Bulletin No.: PIC5757

Service Bulletin

Subject: Blower Motor Inoperative and/or Water In Blower Motor Control Module Area DTC B0193

Models: 2013 Chevrolet Malibu eAssist

2919801

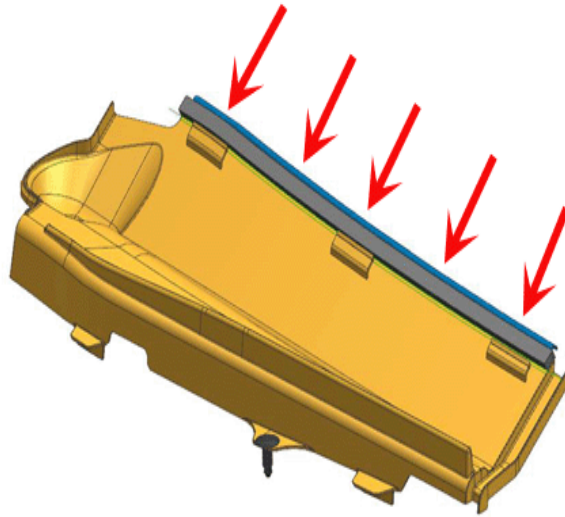
If this concern is duplicated inspect the blower motor, blower motor control module and connectors for signs of water. If water is found it will be necessary to reseal the plenum deflector (see images below) and then replace parts and repair connectors as needed. Remove the air inlet grille to access the plenum water deflector.

Remove the plenum water deflector and add a closed cell foam strip (1/4" tall x 3/8" wide acquired locally) across the entire top of the deflector. Reinstall water deflector and air inlet grille.
